**Re: Application for Site Permit Repowering**  
Trimont Wind Project  
Docket No. IP6907/WS-13-258

**The Application of Trimont Wind I, LLC for a Large Wind Energy Conversation System Site Permit Amendment for Repowering the 100.5 MW Trimont Wind Project in Martin and Jackson Counties**

COMMENTS AND RECOMMENDATIONS OF THE  
MINNESOTA DEPARTMENT OF COMMERCE  
ENERGY ENVIRONMENTAL REVIEW AND ANALYSIS

**In the Matter of the Application of Trimont Wind I, LLC for an LWECS Site Permit Amendment to Repower the 100.5 MW Trimont Wind Project in Martin and Jackson Counties**

Figure 2

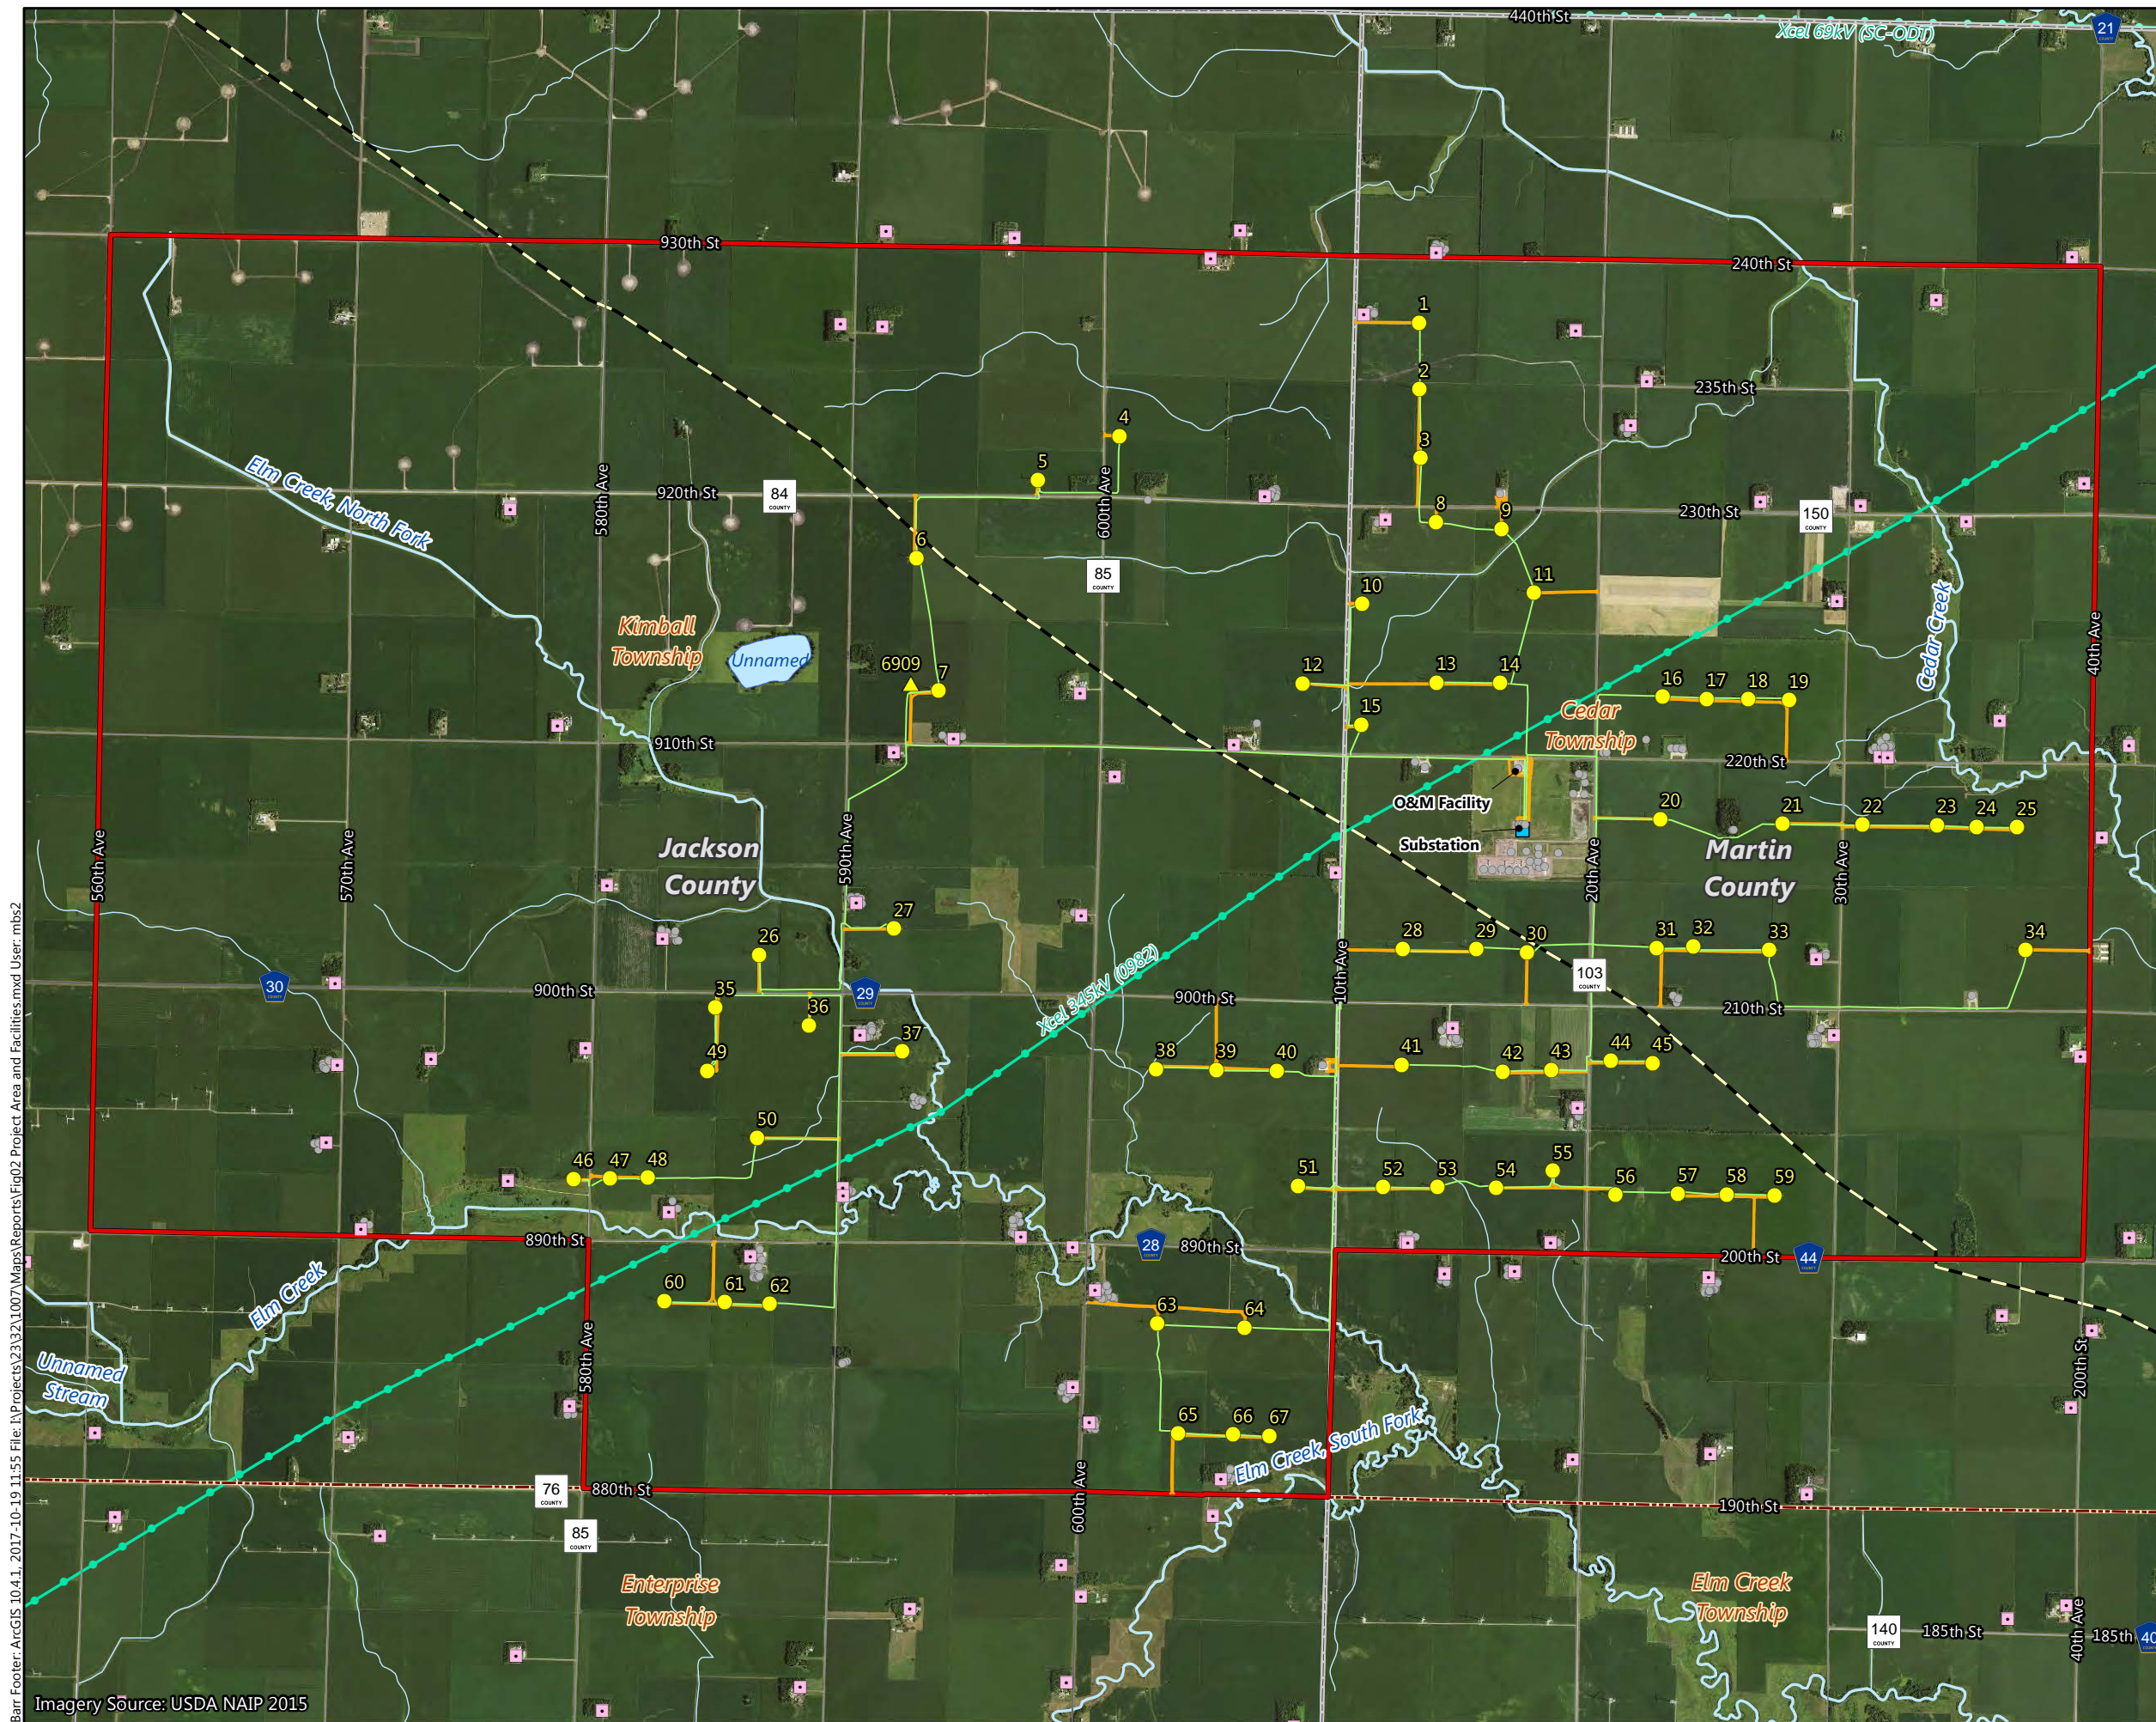
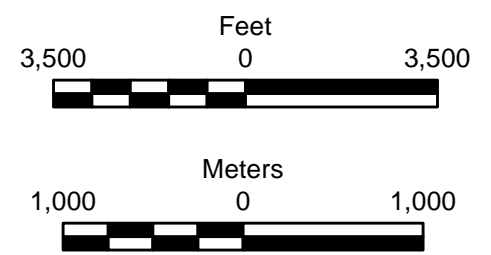
Section	Applicant Recommended Edits	EERA Comments
3.0 Designated Site	<p>The site designated by the Commission for the Trimont Wind Project is the site depicted on the official site permit maps attached to this permit.</p>	<p>The permit should include Figure 2. (Project Area and Facilities) from the Application (see attached).</p>
